IREDELL COUNTY HEALTH DEPARTMENT

IMPROVEMENT PERMIT / AUTHORIZATION TO CONSTRUCT / OPERATION PERMIT / EXISTING SYSTEM

RE: Subject: Soil/Site evaluation for Edwin Ruiz
Owner: Edwin Ruiz
Location: Cornelius Estates, Lot # 2
Pin Number: 4658087009.000
Size: 1.08 acres

INITIAL SITE SKETCH

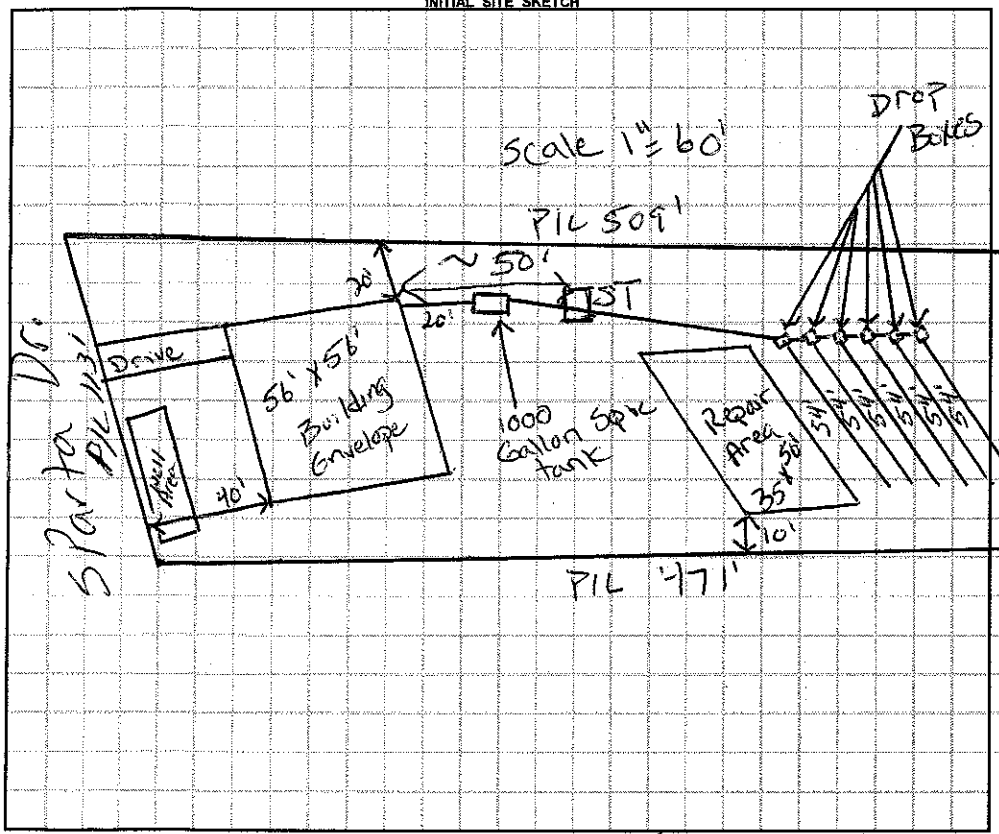
Comments / Conditions: Install a 10" Large Diameter Pipe system on contour with serial distribution. Dig trenches with a 14" bucket, if a 14" bucket is unavailable, then hand installation may be required. Maximum trench depth is 18" on low side ~~3'~~ Install trenches a minimum of 7' on centers.

Checked Upper 4 lines & ST MD

Checked Lines 5 & 6 on 3/26/15 Essentially Installed As Drawn. SC

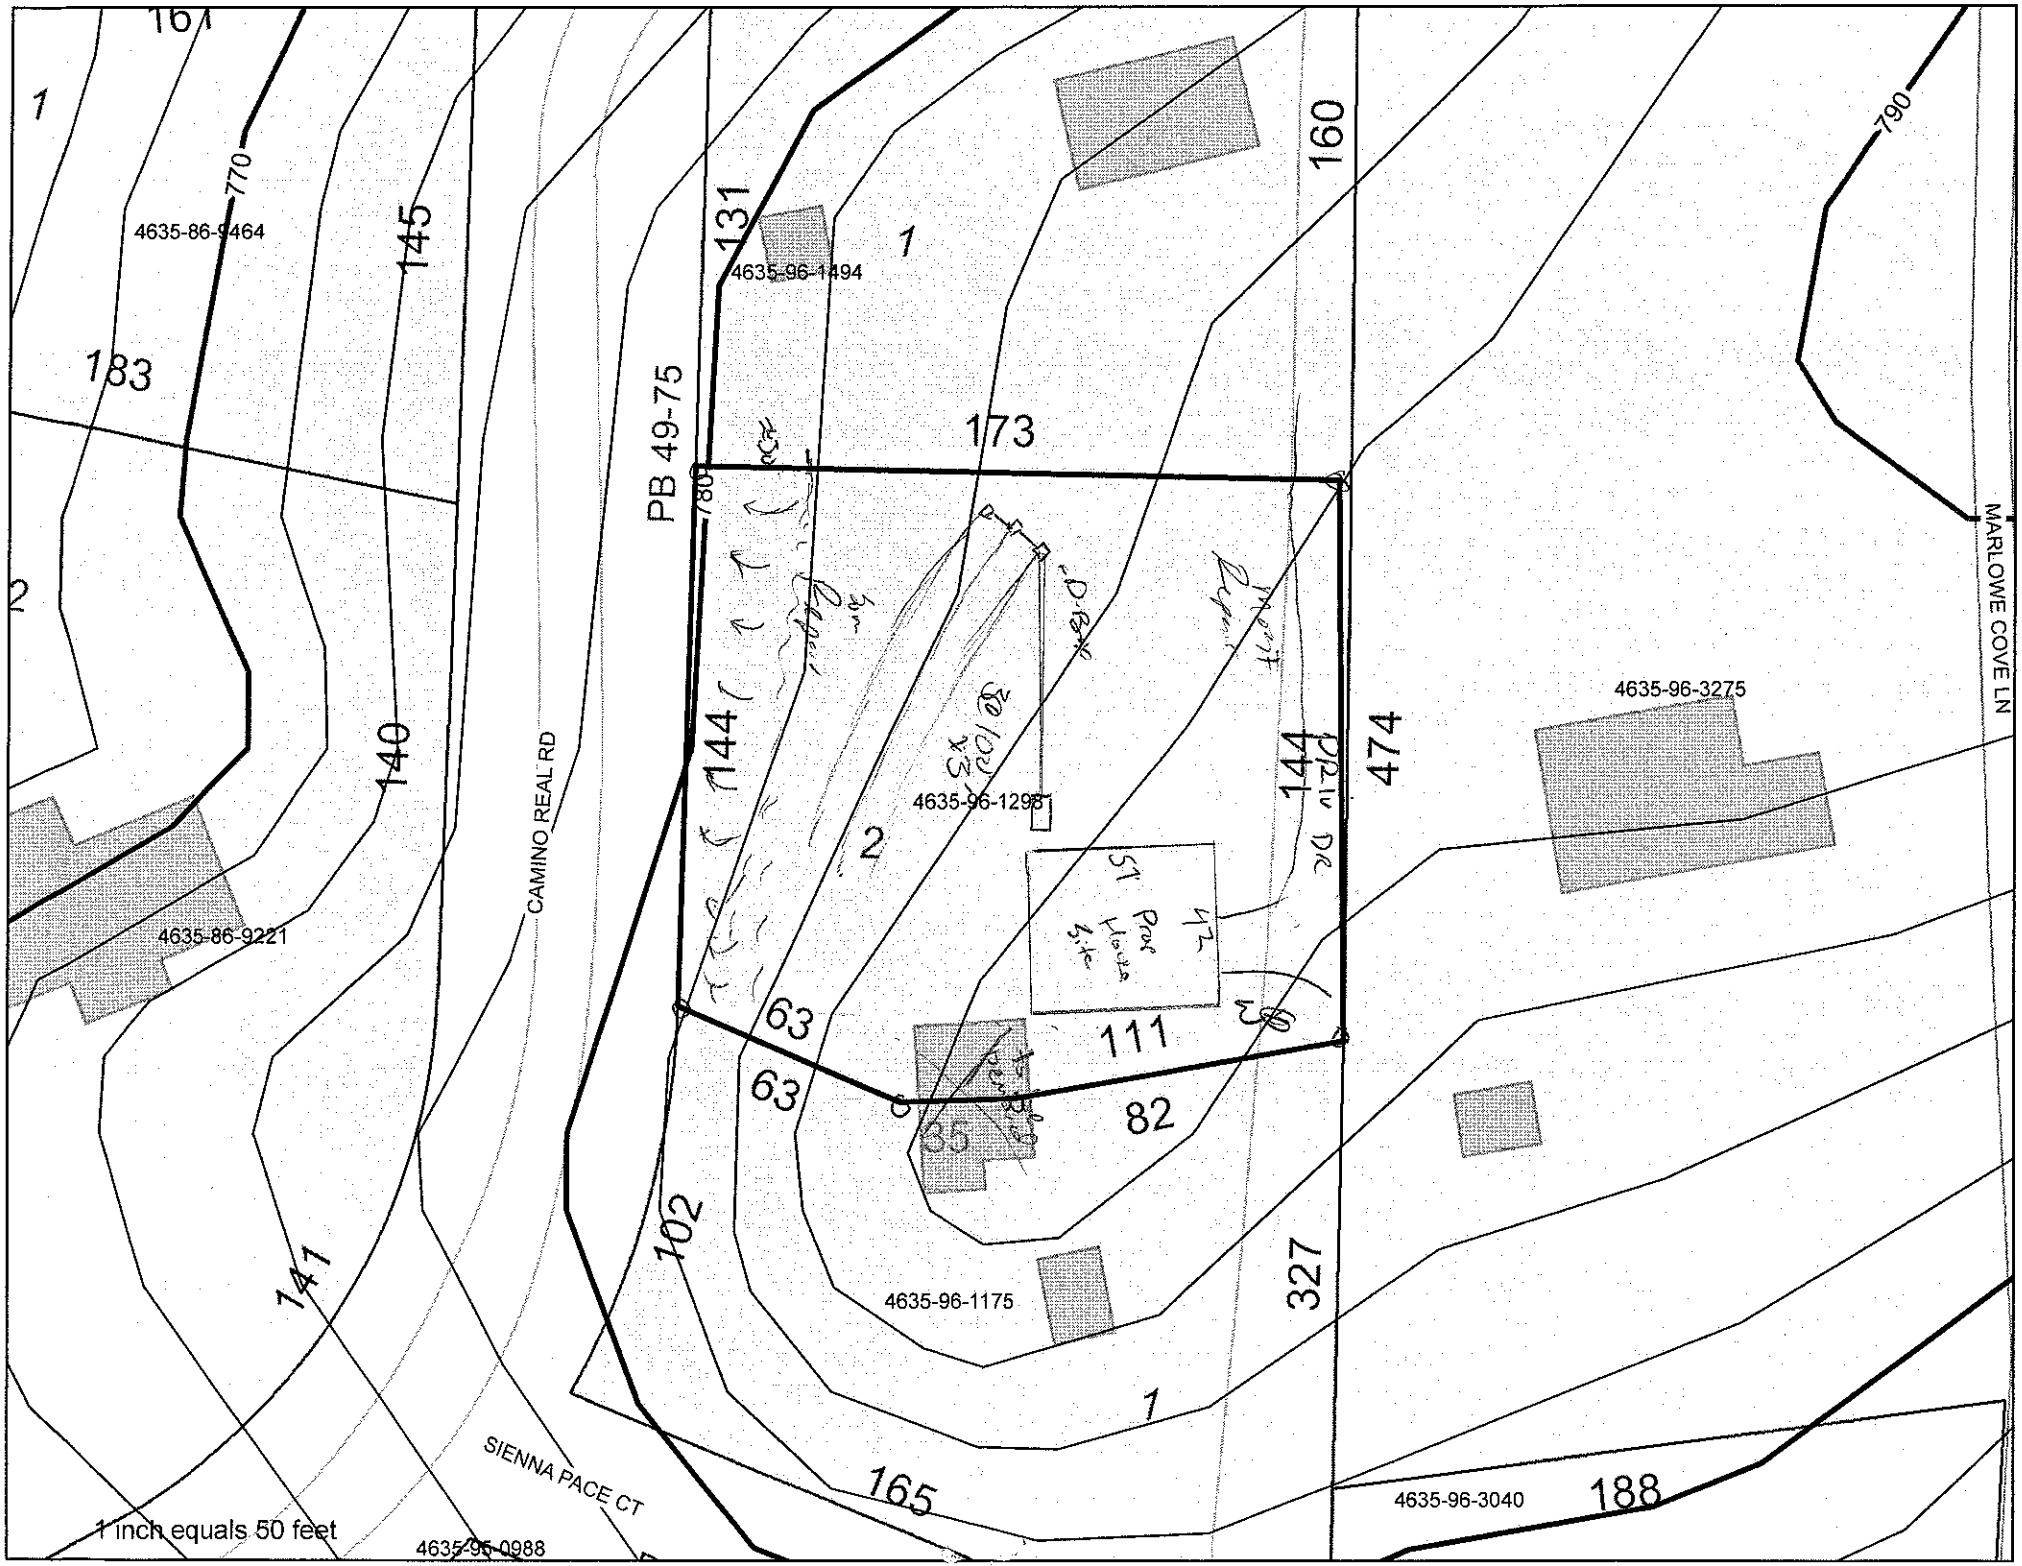
Available Space (Rule .1945)- The space on the property with soils that can be classified as suitable or provisionally suitable (i.e. usable/modifiable soils) for the installation of an initial and a repair ground absorption sewage treatment and disposal system was not determined at during my evaluation. The provisionally suitable soil area was bounded on the sides by the 10' property line setback, on the bottom by complex (unsuitable) topography and on the top by the shallow soil depth described in pits 1 and 2. A general

site plan is attached. A ten (10) foot horizontal separation distance to any property line is required due to the property recording/plat date occurring after July 1, 1977. A review of the Iredell County Registry indicates the property/lot was recorded after January 1, 1983.

The drainfield lines need to be laid out on the site, within the provisionally suitable area, to determine the number of bedrooms available.

System Type: 10" Large Diameter Pipe
LTAR: 0.45 (pit 3)
Trench Depth: 18" on the lower side wall
Trench Width: 14" This with of a bucket may be hard for an installer to attain. If a 14" wide bucket (12" with the side cutter) cannot be found then hand installation may be required. This should be discussed with the applicant and their installer as soon as possible.
